SANDSTONE PRECINCT

23-39 BRIDGE STREET
SYDNEY NSW, 2000

**PROPOSED PLANS - LANDS BUILDING -
LOWER GROUND, EDUCATION BUILDING -
BASEMENT 01**

FOR APPROVAL

TITLE
**PROPOSED PLANS - LANDS BUILDING -
LEVEL 06, EDUCATION BUILDING - LEVEL 05**

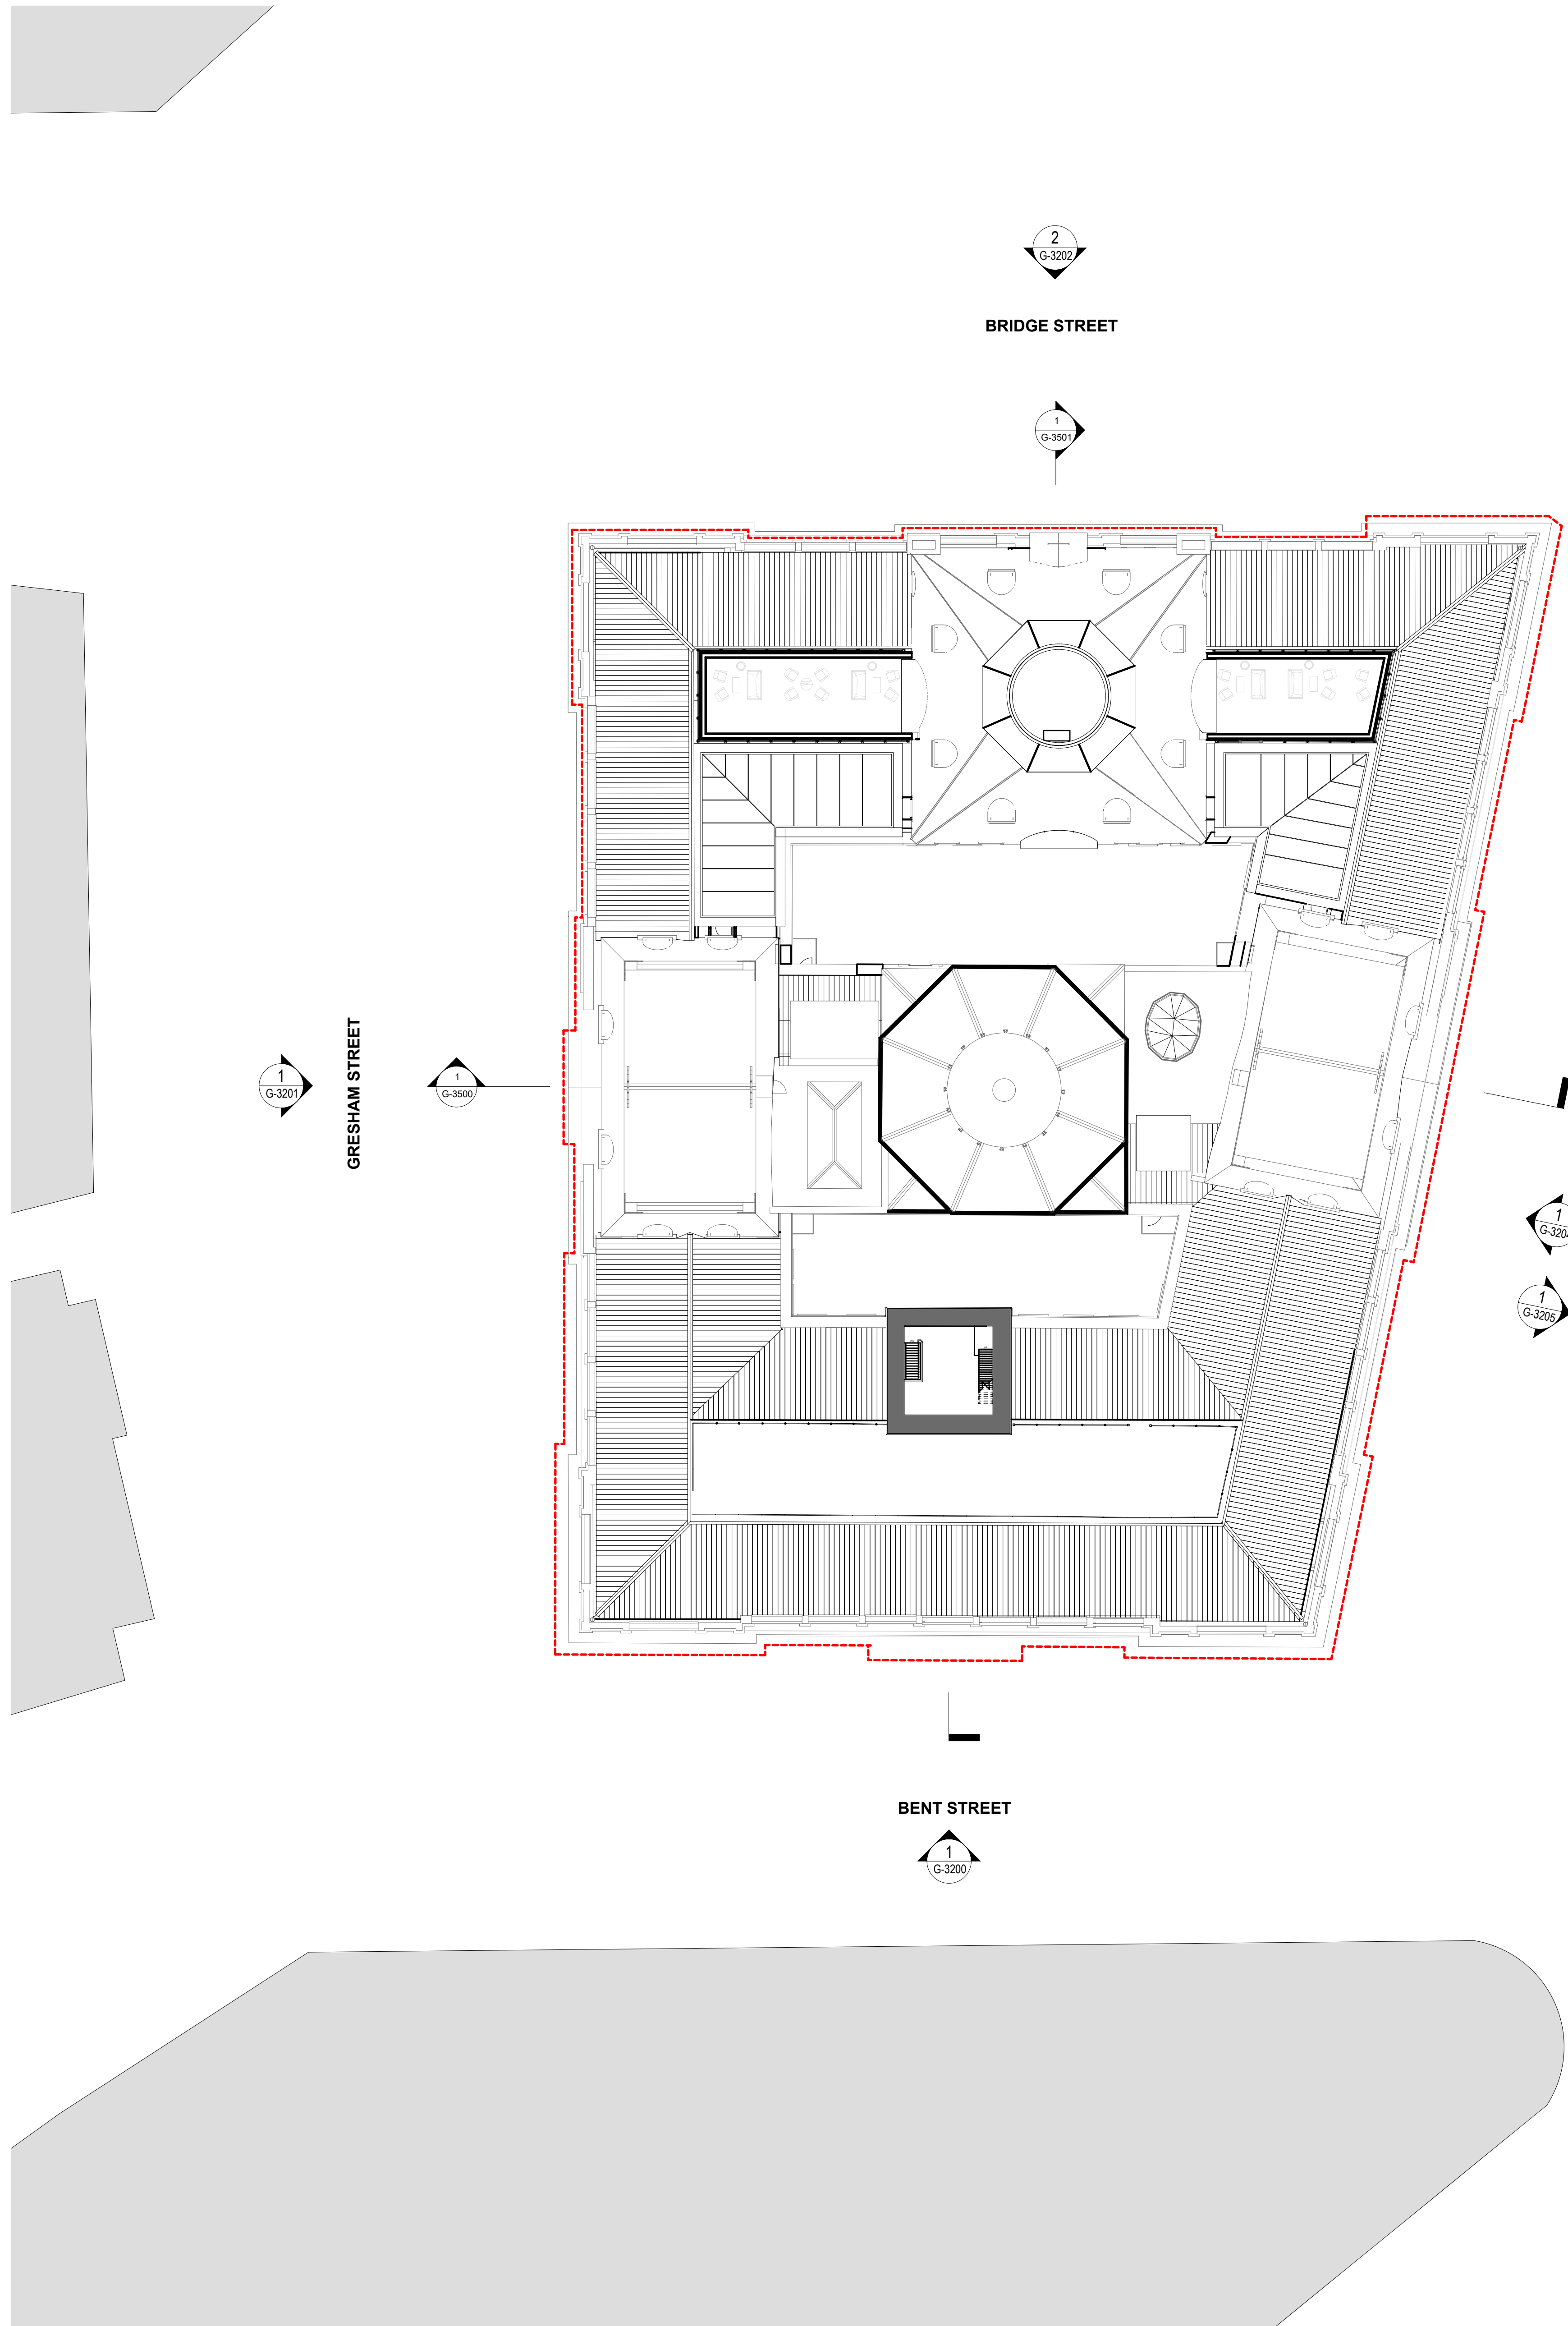
- EDUCATION BUILDING KEY COUNT: 18
- CHANGES LEGEND:
- (01) CURVED GLASS CHANGED TO 1500MM RADII
 - (02) CURVED GLASS REMOVED
 - (03) AWNING REDUCED IN WIDTH
 - (04) BACKPAN ADDED TO GLASS PANELS

TITLE
**PROPOSED PLANS - LANDS BUILDING -
LEVEL 07, EDUCATION BUILDING - LEVEL 06**

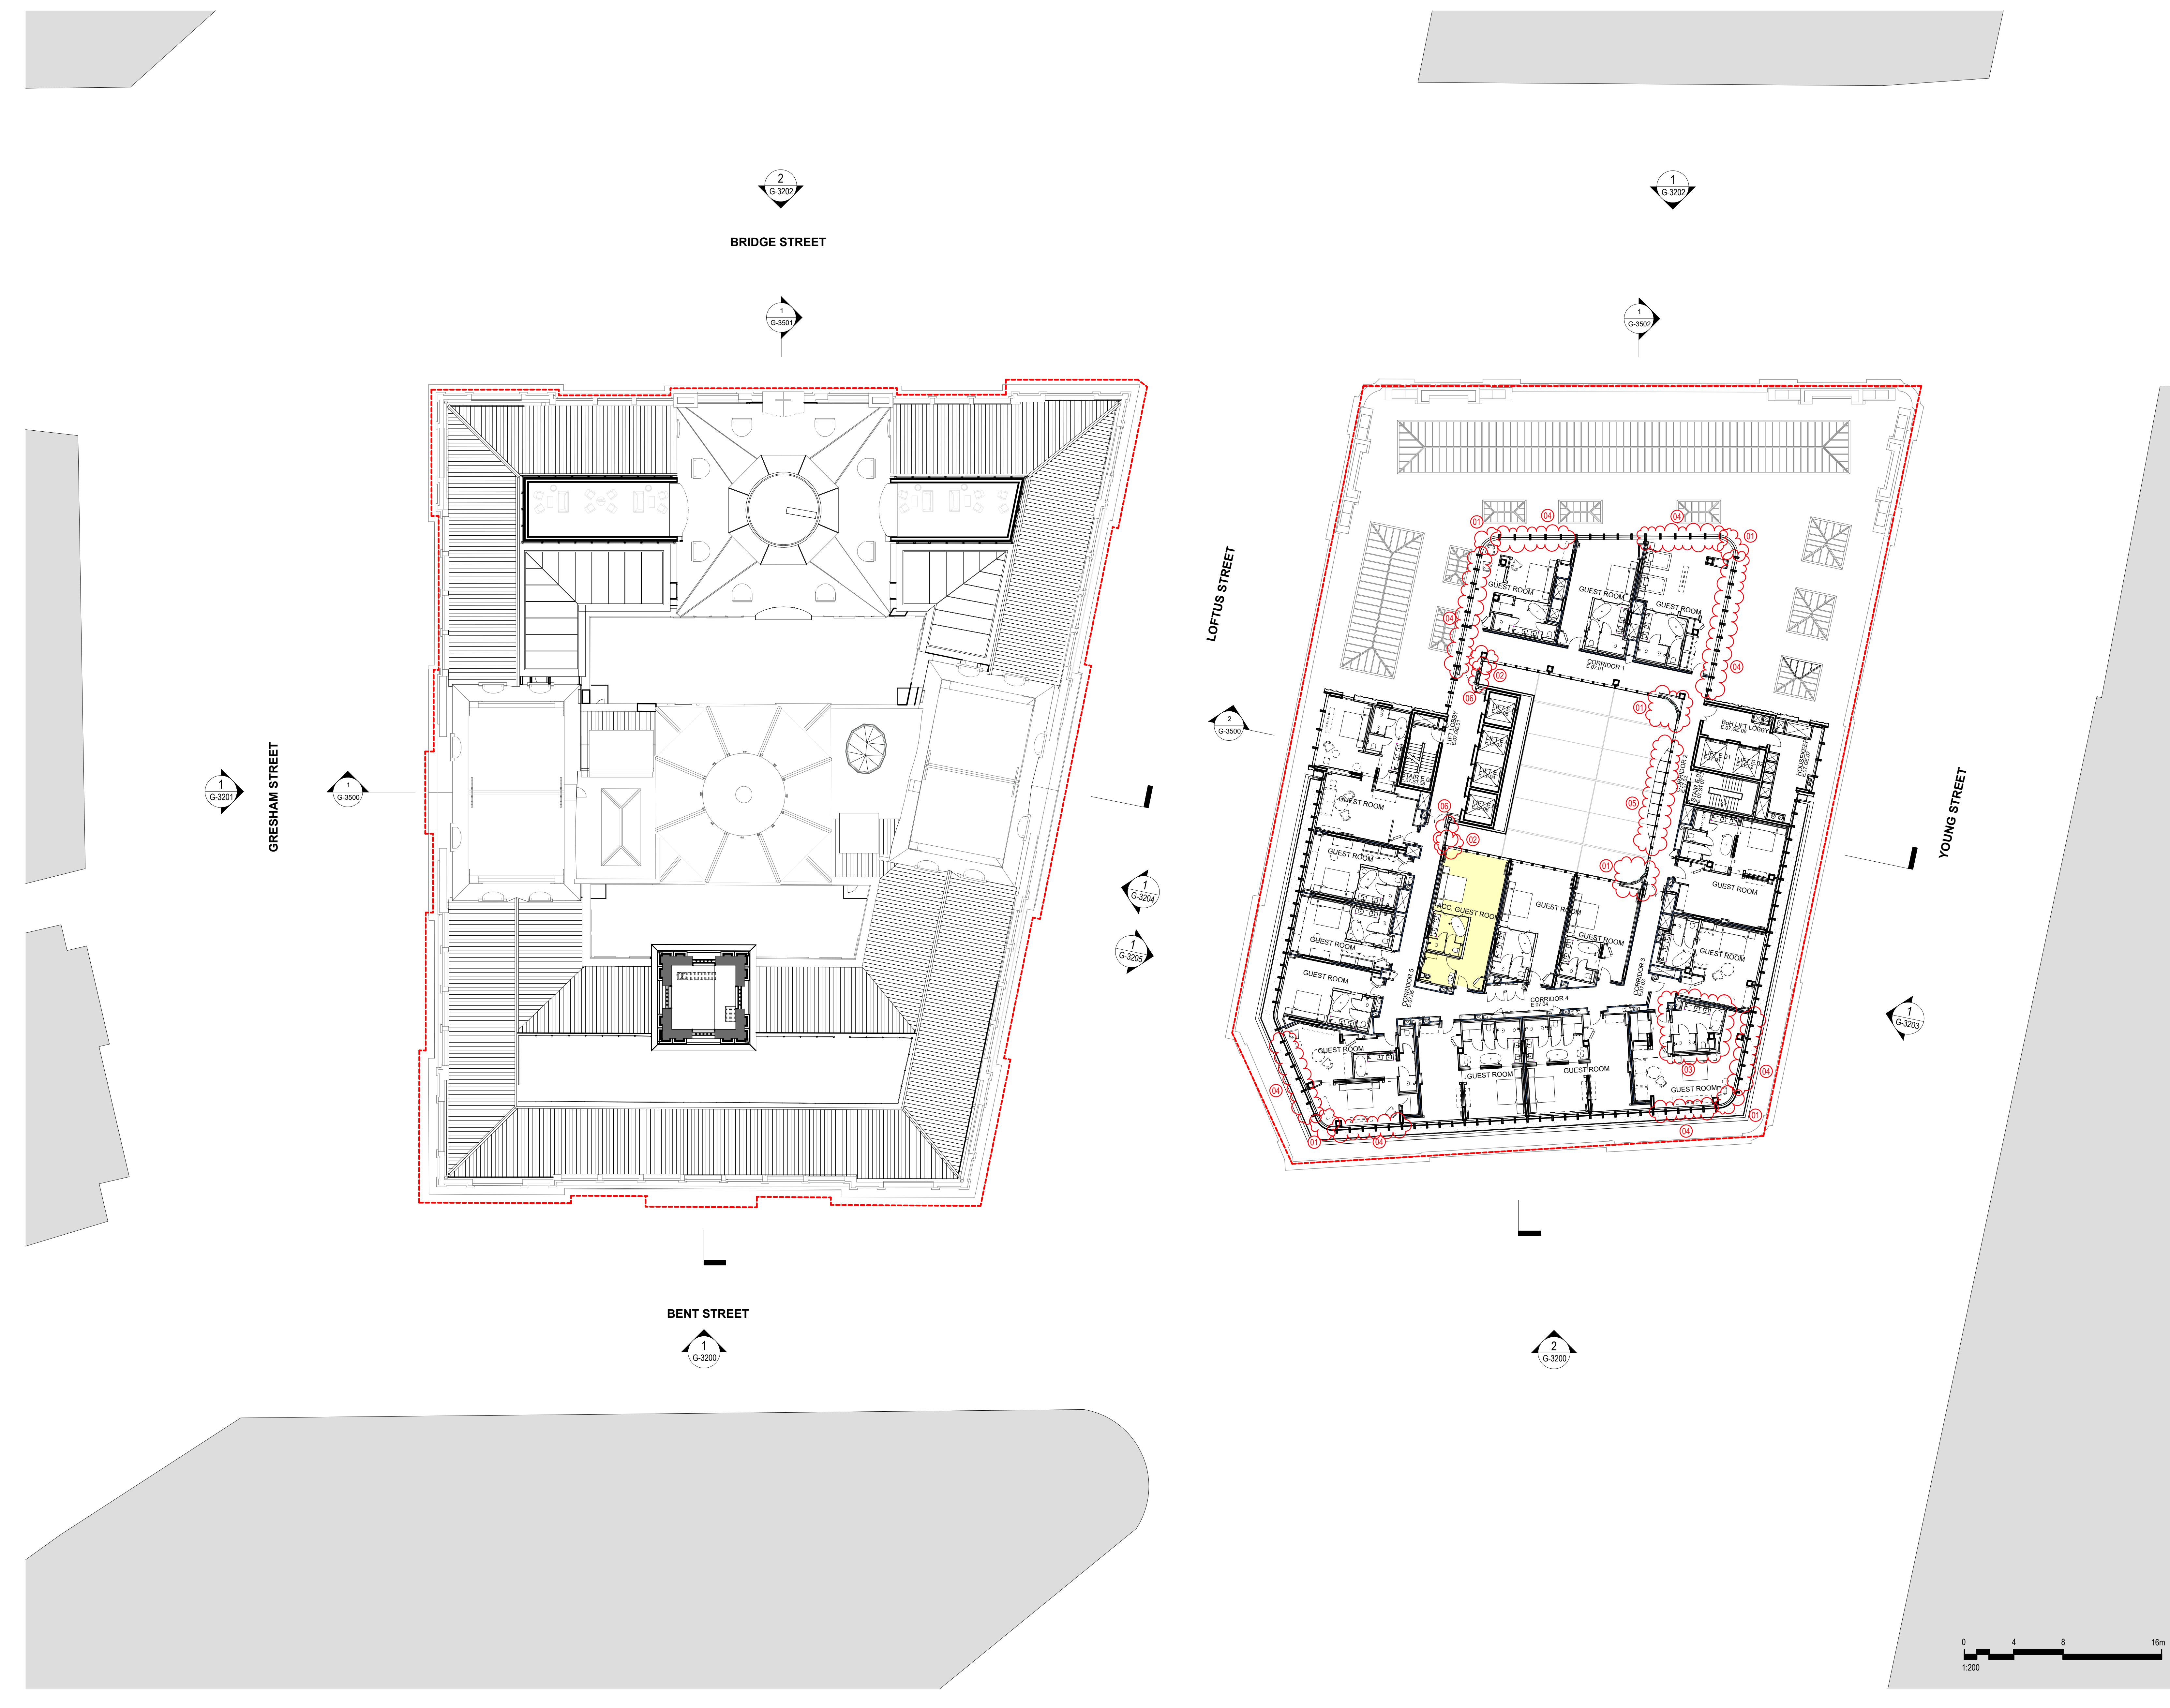
- 01 CURVED GLASS CHANGED TO 1500MM RADIUS
- 02 CURVED GLASS REMOVED
- 03 UPDATED CURTAIN WALL SPACING
- 04 AWNING REDUCED IN WIDTH
- 05 BACKPAN ADDED TO GLASS PANELS

PROPOSED PLANS - LANDS BUILDING - LEVEL 08, EDUCATION BUILDING - LEVEL 07

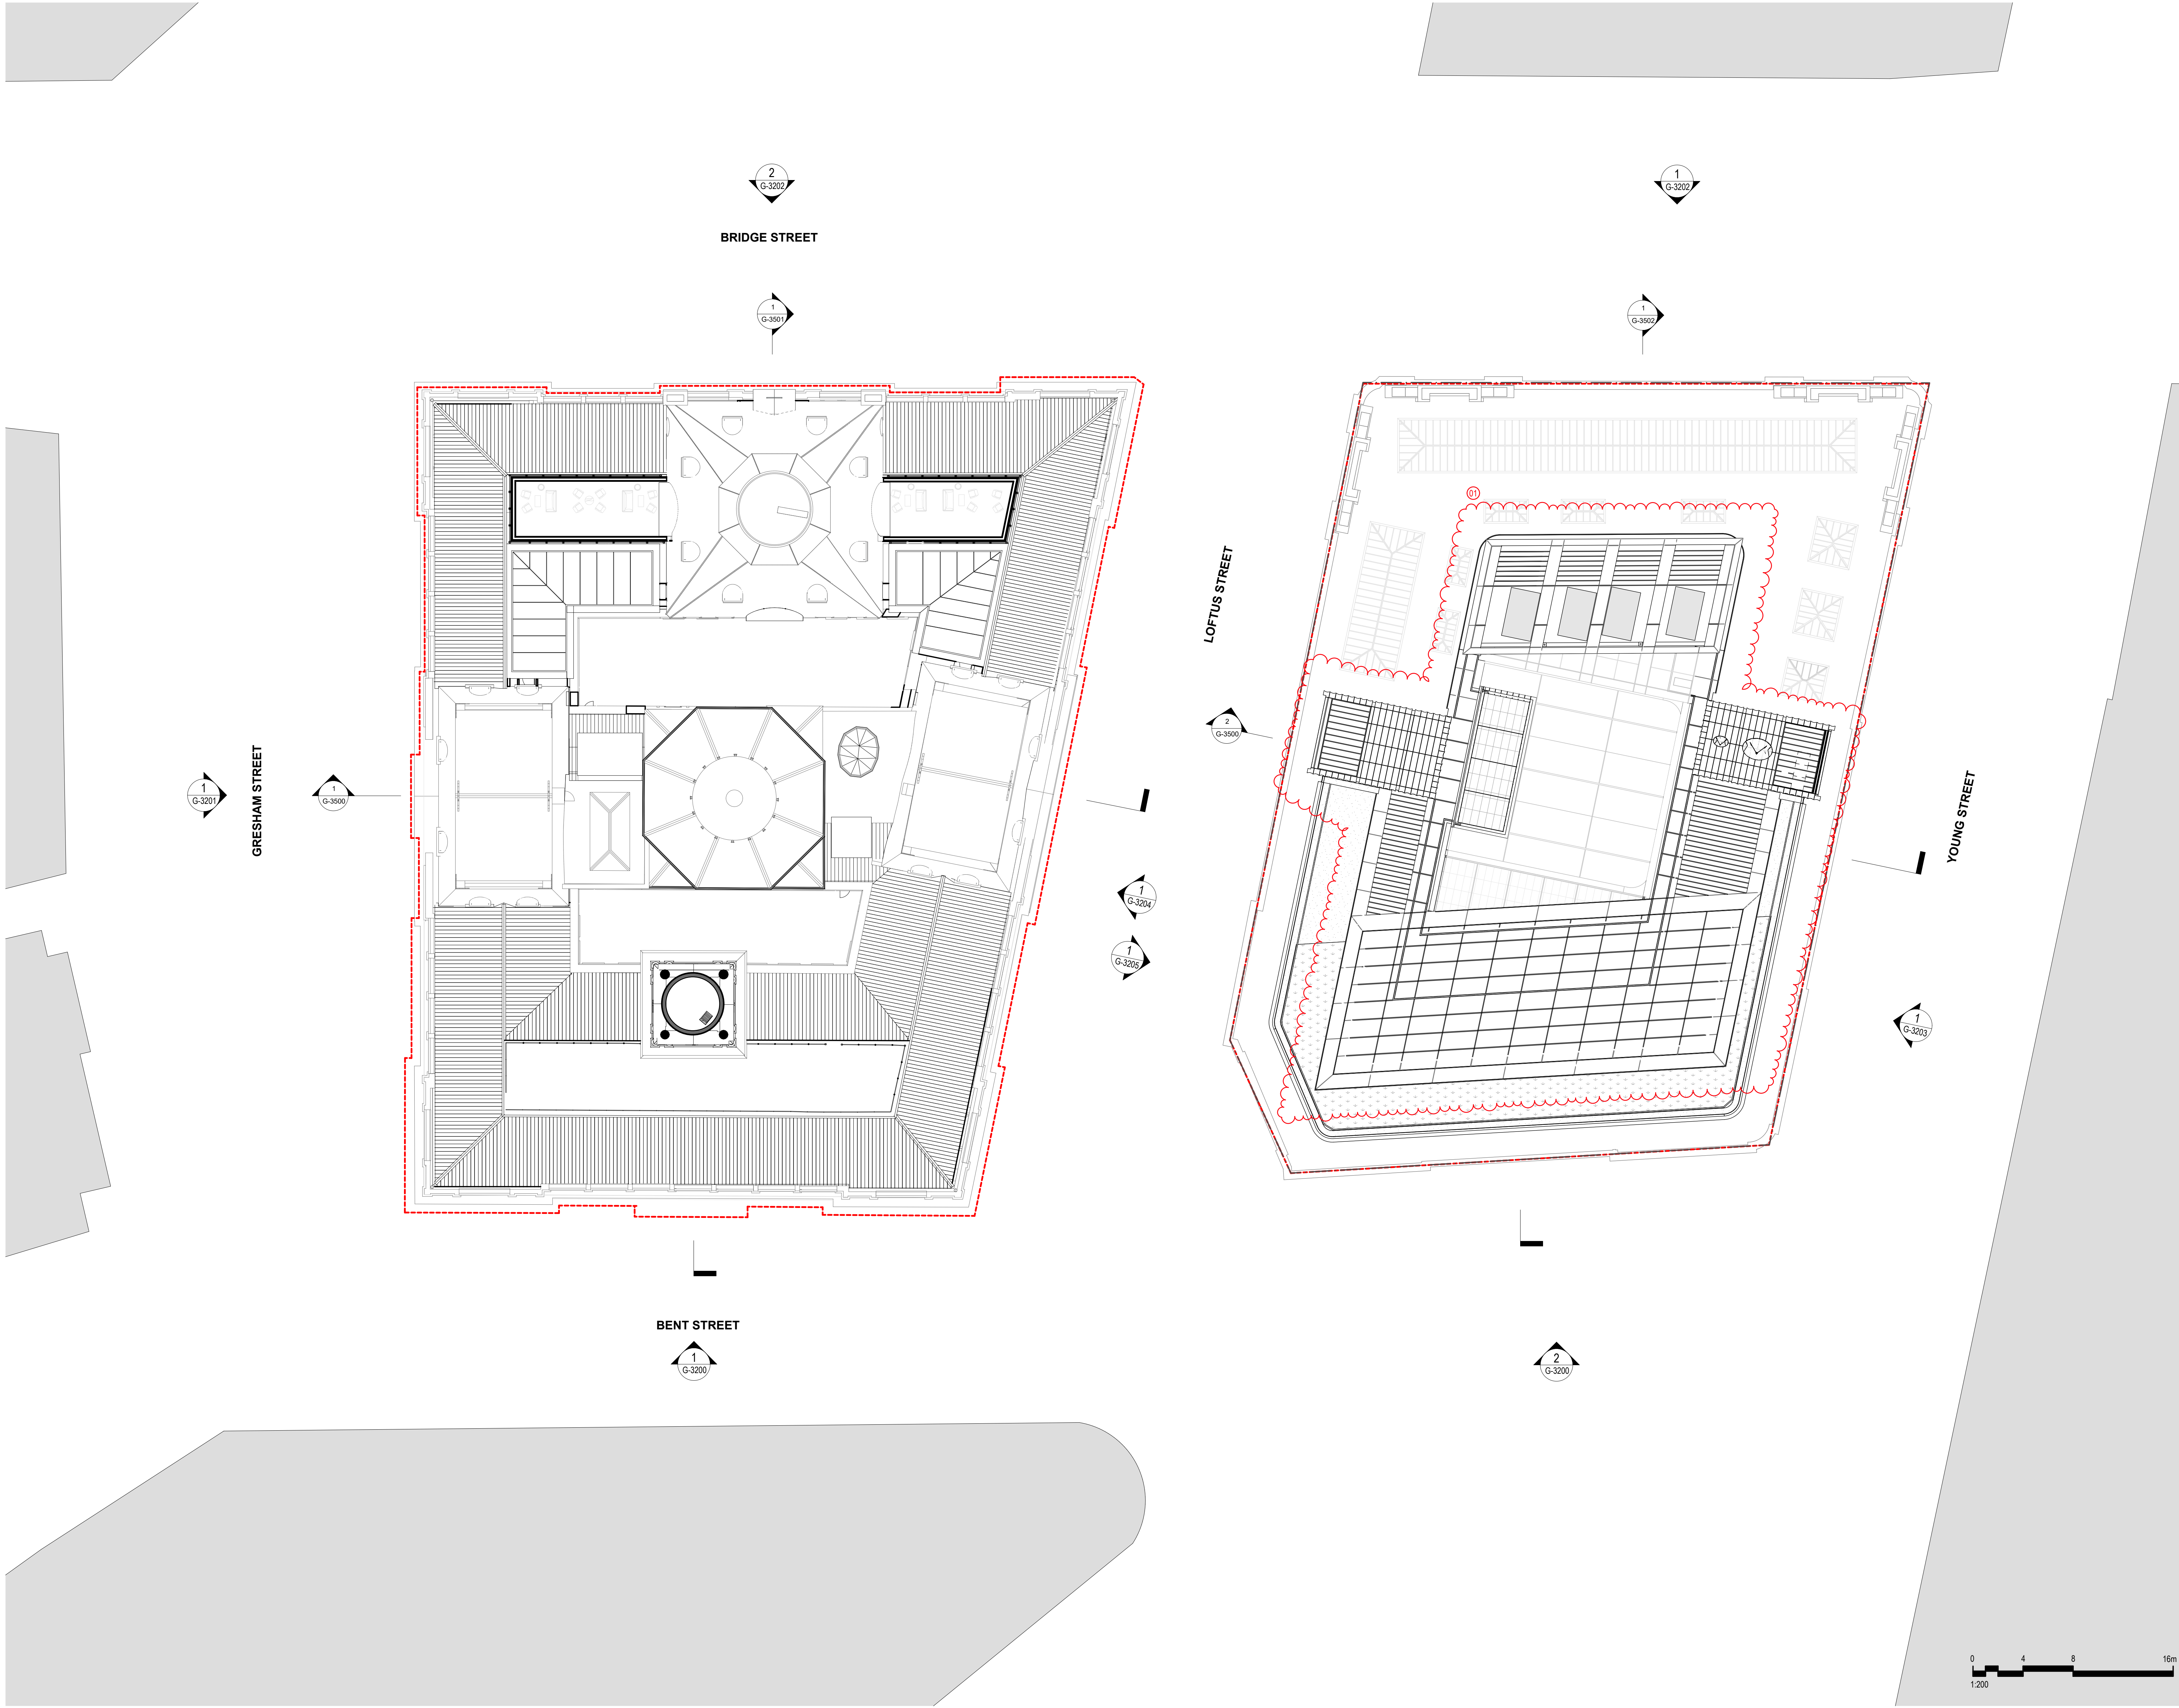
01 CURVED GLASS CHANGED TO 1500MM RADIUS

02 CURVED GLASS REMOVED

03 GUEST ROOM ENSUITE LAYOUT UPDATED

06 BACKSPAN ADDED TO GLASS PANELS
